West Burton Solar Project

~~Draft~~ Statement of Common Ground with Historic England Revision A (Tracked)

PINS reference: EN010132

Document reference: ~~EX1EX5~~/WB8.3.3 A

Figure 1. Location of heritage assets associated with Stow Park Deer Park, Stow Deserted Medieval Village and a possible early medieval settlement in the west of West Burton 3.

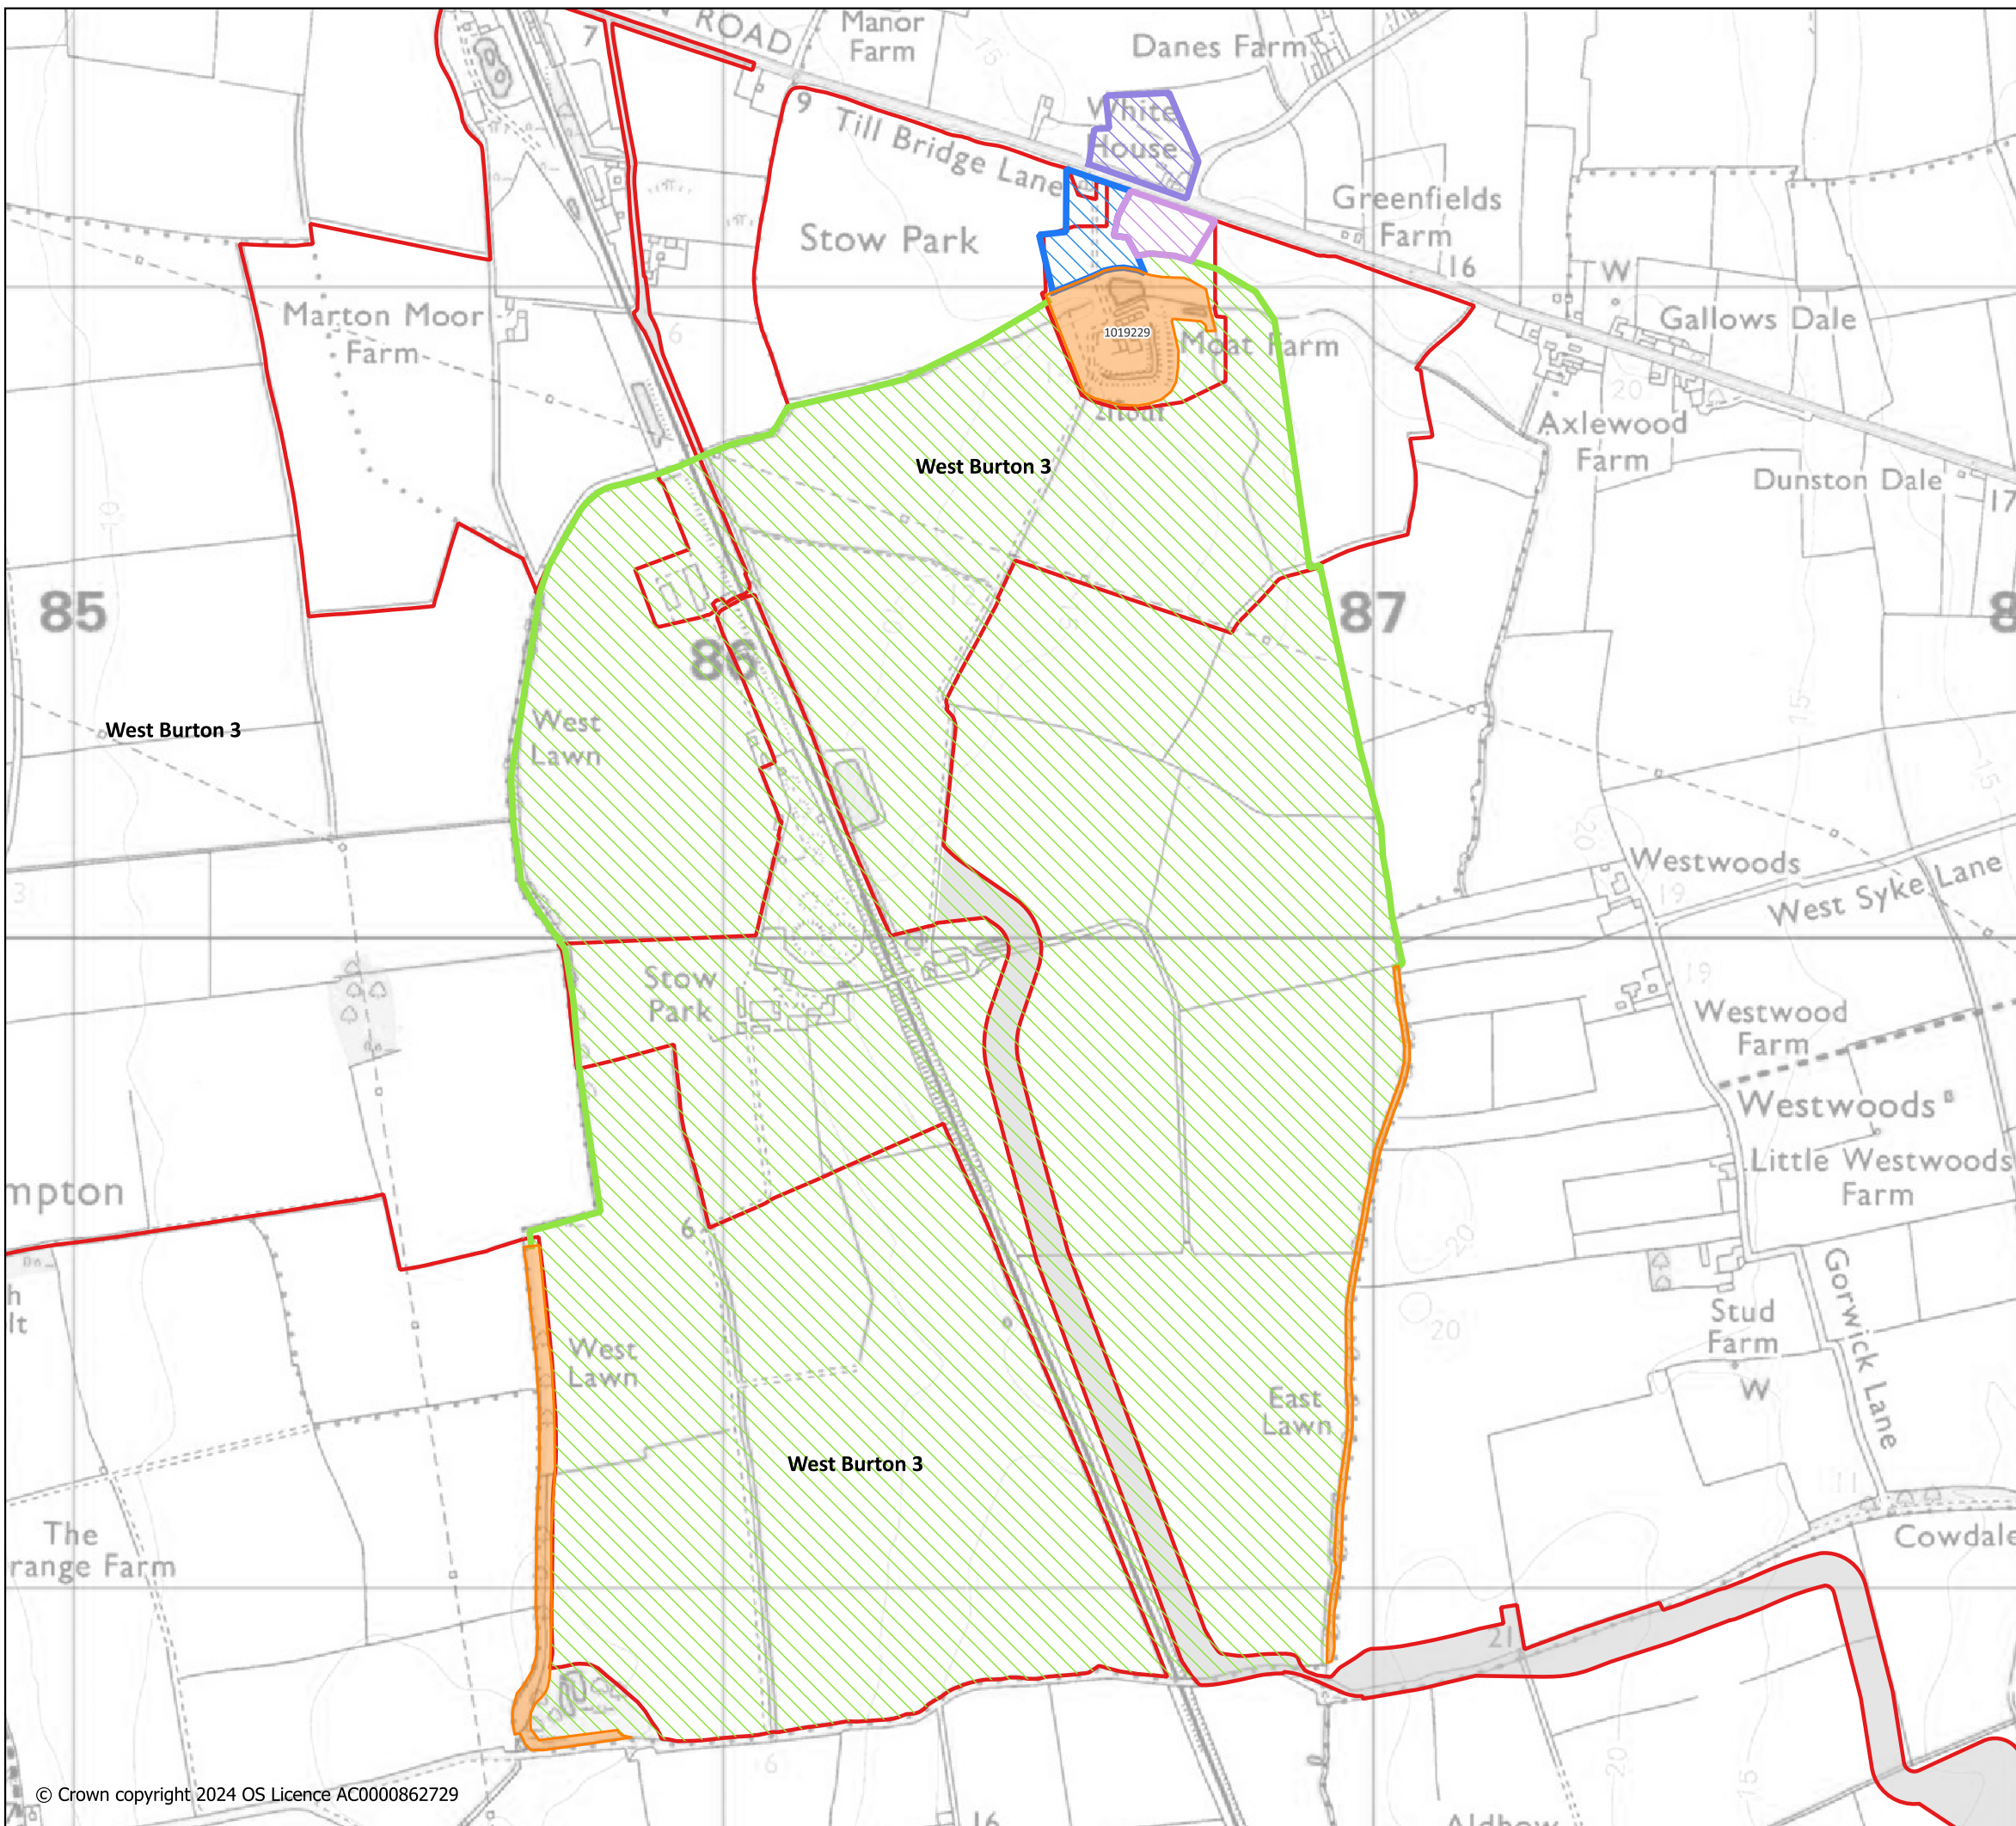
<p>Deer Park Scheduled Monument. However, as identified in Paragraph 3.3.35 of the Heritage Statement [APP-117 to APP-119], the Applicant believes that the relationship between the three surviving components of the Deer Park has already been adversely compromised: modern activity including the ex-MOD petroleum storage facility and a railway line completely bisect the Deer Park, resulting in there being no intervisibility between the west park pale, and the Bishop's Palace and east park pale. Whilst theoretically intervisibility exists between the Bishop's Palace and the east park pale, their historical relationship is only experienced through the fossilisation and demarcation of the parkland boundary by later mature trees and hedgerow. Further to this, the Applicant highlights that the northern section of the Deer Park has limited legibility. Desk-based research has demonstrated that there are several possibilities for the locations of the pales in the north of the Deer Park, which would have each joined the east and west park pales to the Bishop's Palace (Paragraphs 3.2.27-3.2.48 [APP-117 to APP-119]). During a meeting on the 3rd April 2024 the Applicant agreed the most likely boundary of Stow Park Deer Park with Historic England (see Figure 1)</p>
